UNITED STATES PATENT AND TRADEMARK OFFICE

APPLICATION NO.	FILING DATE	FIRST NAMED INVENTOR	ATTORNEY DOCKET NO.	CONFIRMATION NO.
09/939,647	08/28/2001	Shigeru Umehara	N99147USDIV	5529

DATE MAILED: 12/01/2003

FIG. 2

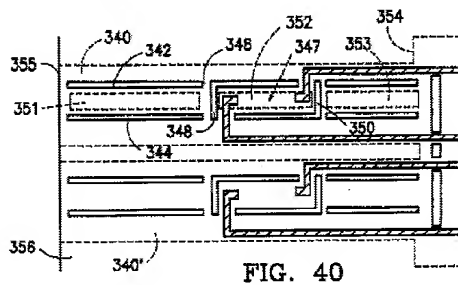
forming a pressure generating chamber 7 from a chamber plate with a pair of sides such that said pair of sides are substantially smooth surfaces (Fig.2), and

forming a plurality of ink outlet passages arranged into a pair of parallel rows (see Fig.2),

wherein said plurality of ink outlet passages 2, 3 communicate with said pressure generating chamber, and

FIG. 7

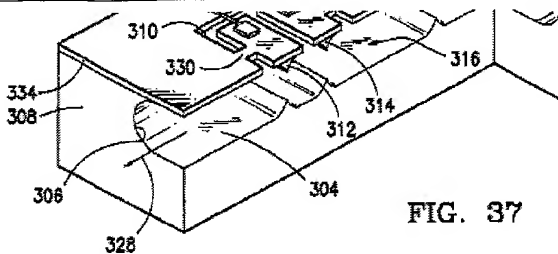
wherein said plurality of ink outlet passages comprise an upper passage portion 45 and a lower passage portion 43, and said upper and lower portions are each substantially hemispherical (Fig.7).
